Appl. No. 10/085,175
Amdt. Dated June 5, 2004
Reply to Office Action March 05, 2004

Amendments to the Drawings

REPLACEMENT DRAWINGS

FIG. 1

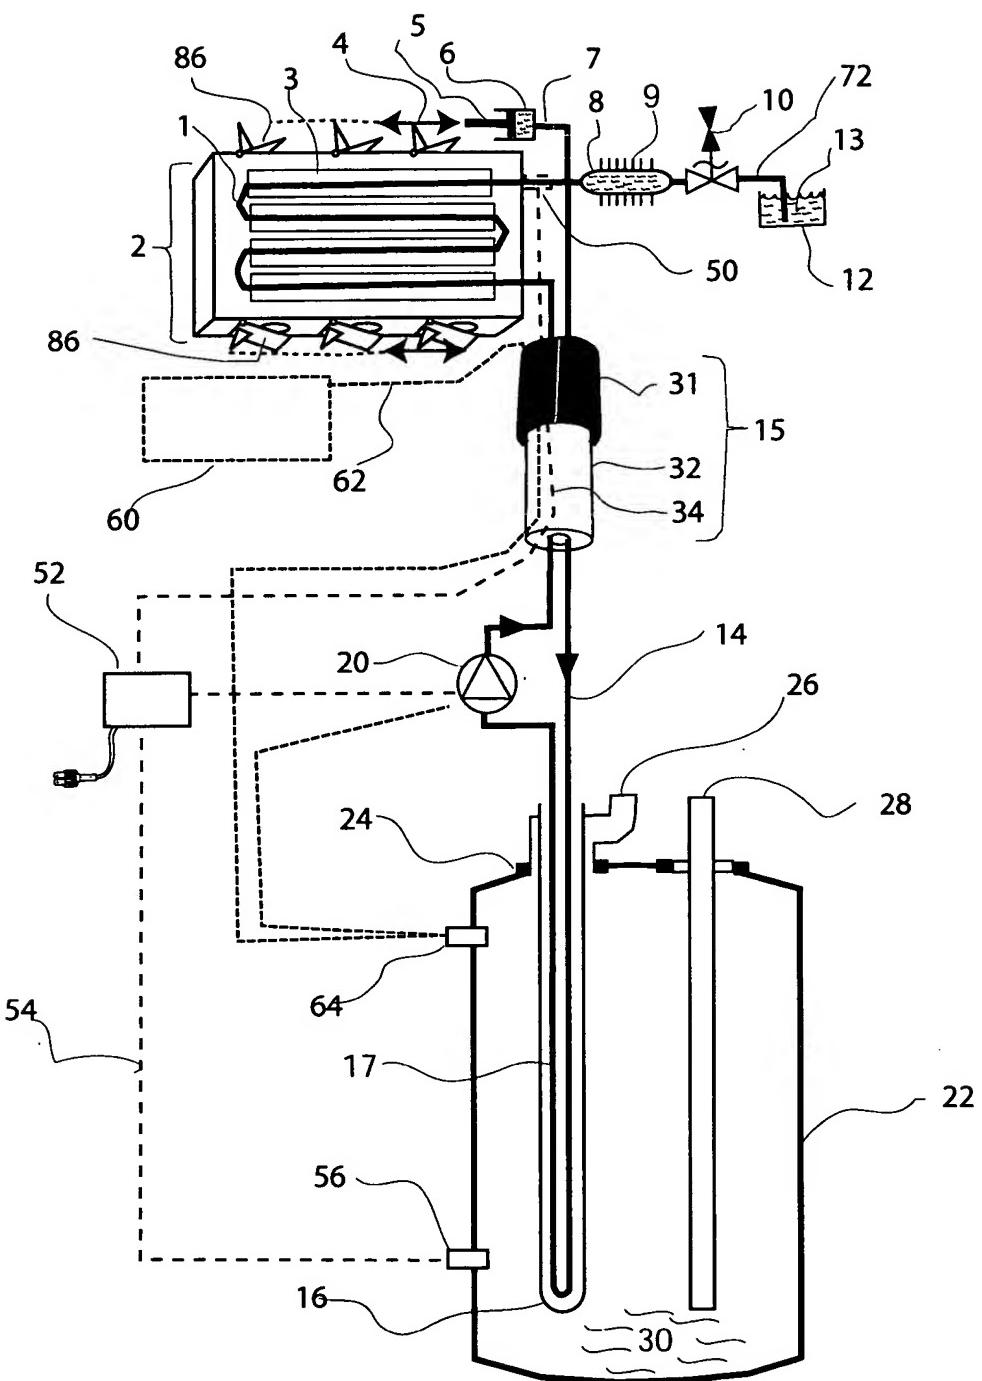
(Revised): Fig. 1 has been revised to meet patent office specifications for numbering, circles around numbers and text have been removed. The hot water tank has been cross-sectioned to accurately show the heat exchanger. The original Figure 1 showed a double wall heat exchanger which is more clearly shown in the cross section. (Revised Sheet Provided in Appendix)

FIG. 2

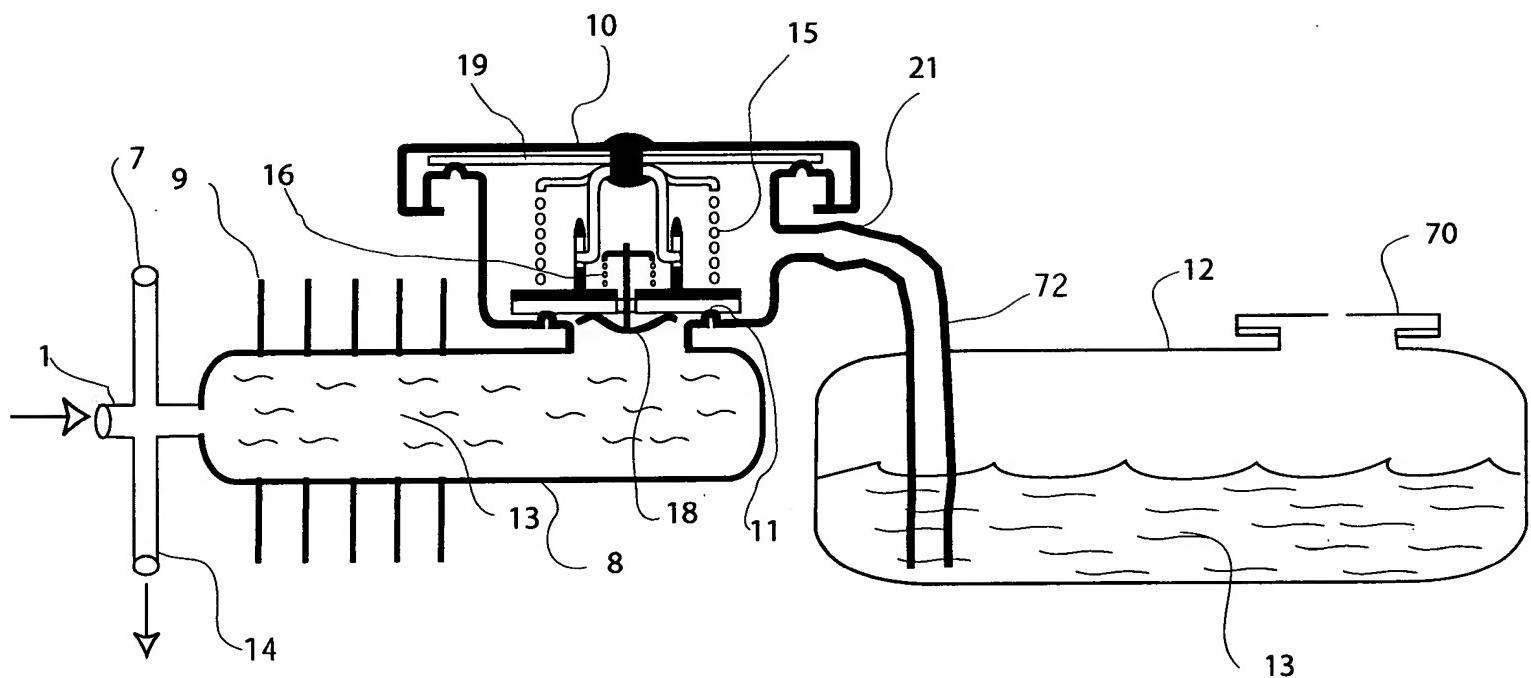
(Revised): Fig. 2 has been revised to meet patent office specifications for numbering, circles around numbers and text have been removed. The pressurized reservoir was amended to show the cooling fins consistently on Figures 2 and 4. (Revised Sheet Provided in Appendix)

FIG. 3

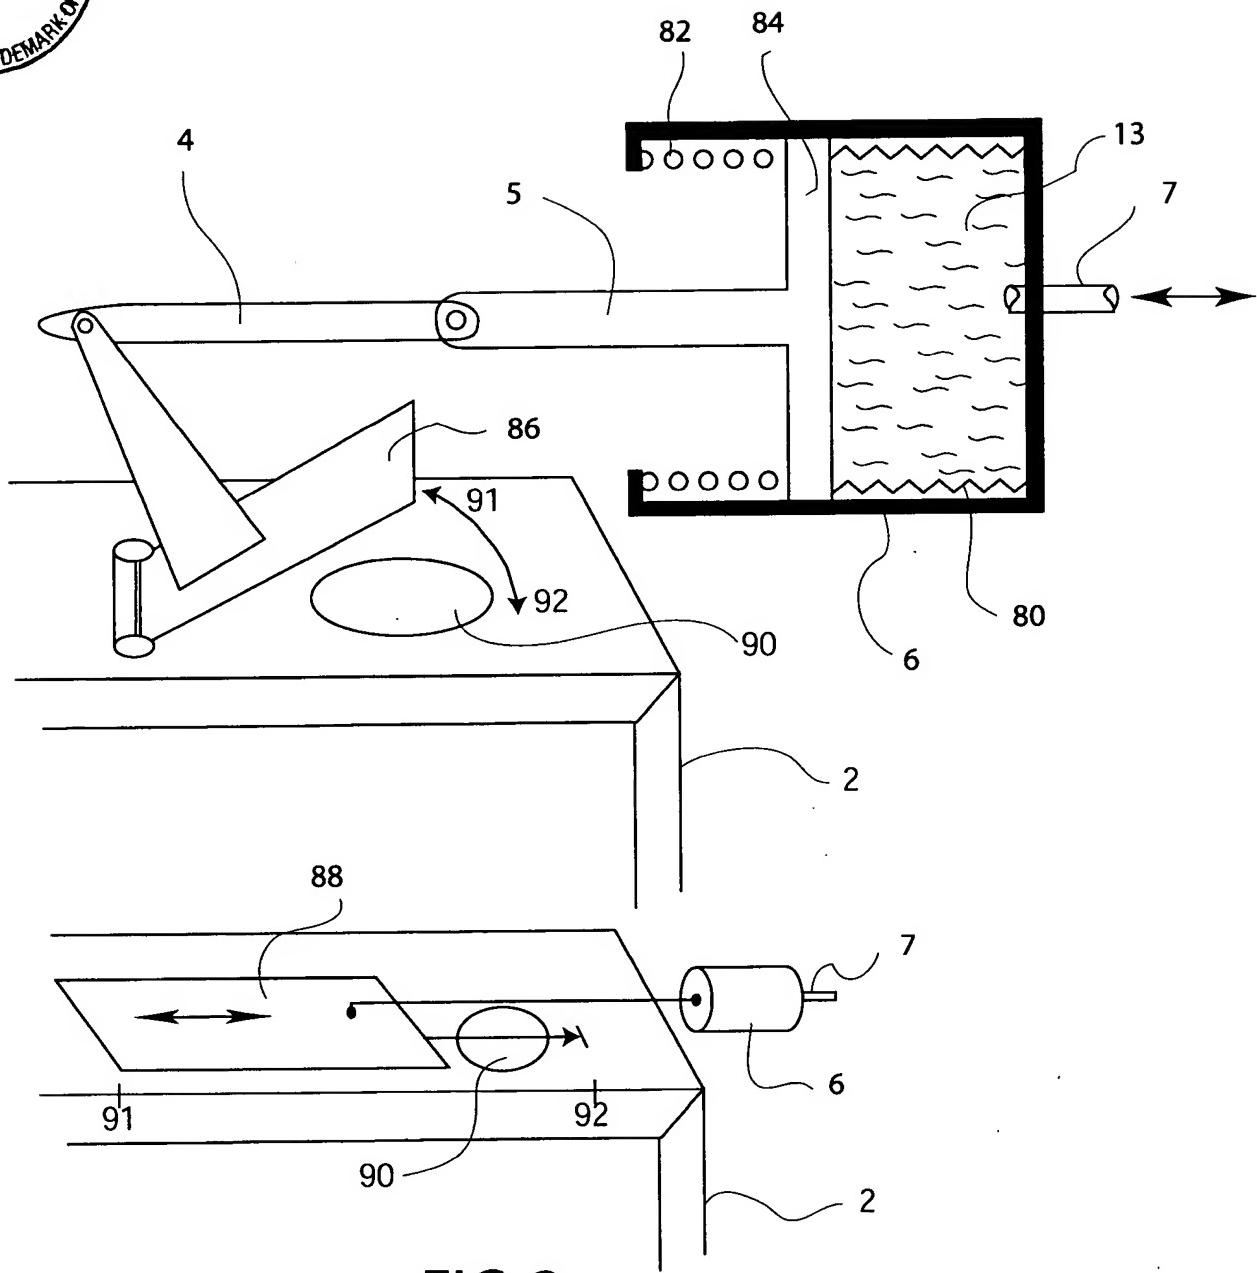
(Revised): Fig. 3 has been revised to meet patent office specifications for numbering, circles around numbers and text have been removed. The inset was removed and placed in a new Fig. 5 (Revised Sheet Provided in Appendix)

FIG. 4

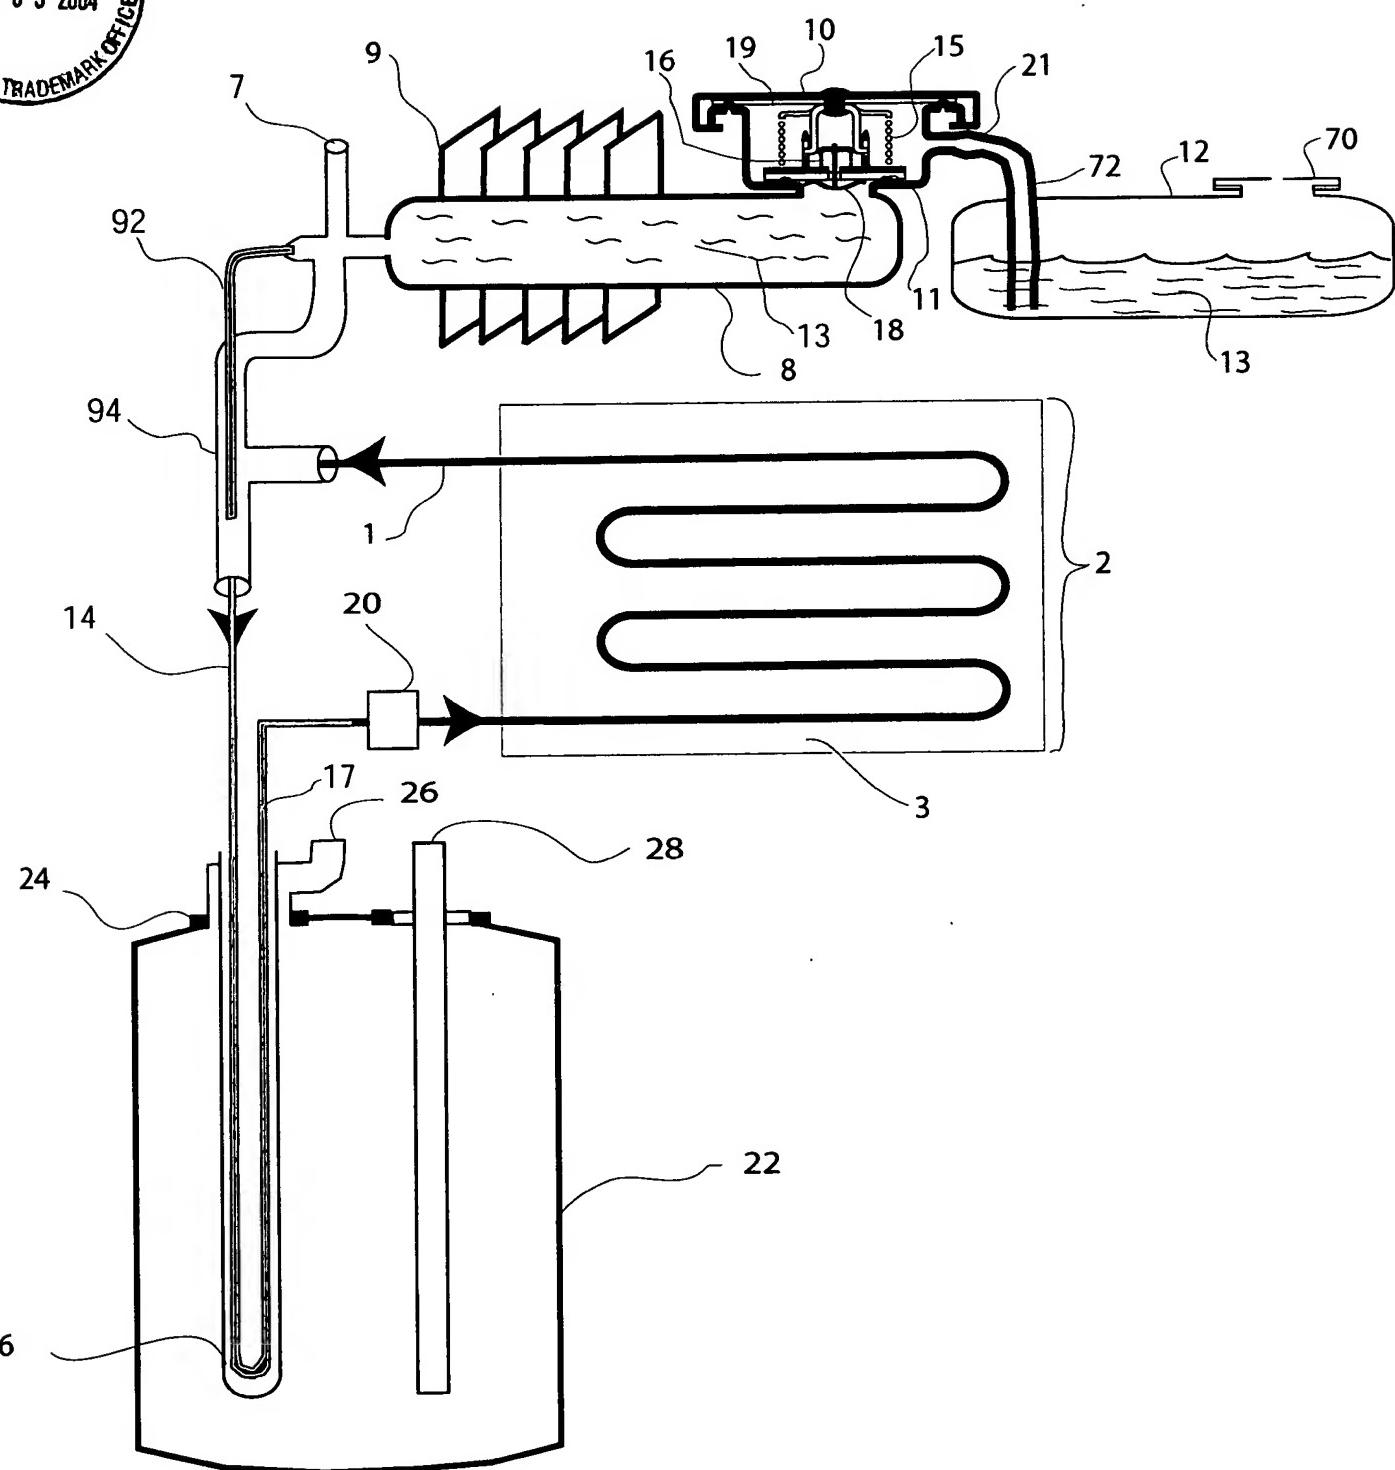
(Revised): Fig. 4 has been revised to meet patent office specifications for numbering, circles around numbers and text have been removed. The pressurized reservoir was amended to show the cooling fins on the reservoir, not as a folded tube radiator. (Revised Sheet Provided in Appendix)

FIG. 5

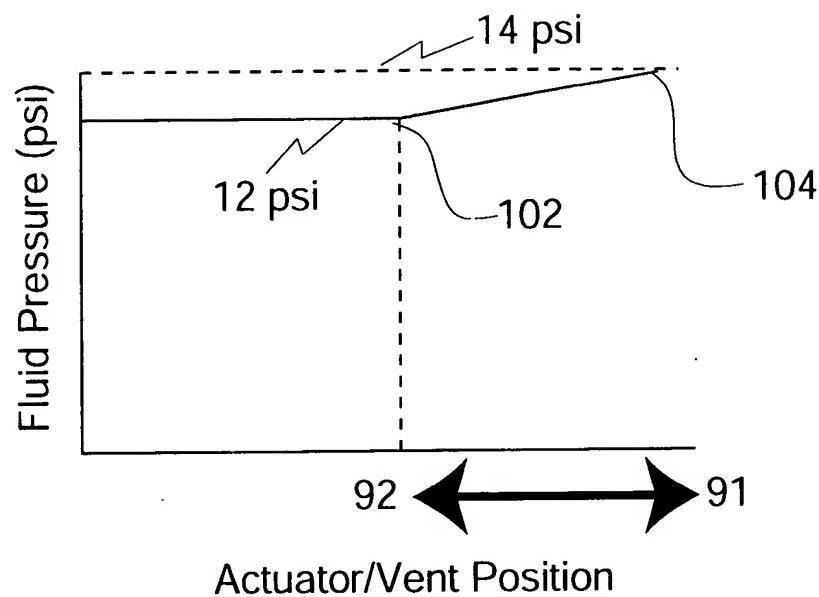
(New): Fig. 5 has been revised to meet patent office specifications for numbering, circles around numbers and text have been removed. This figure was an inset in Fig. 3 and has now been made a separate figure. (Revised Sheet Provided in Appendix)
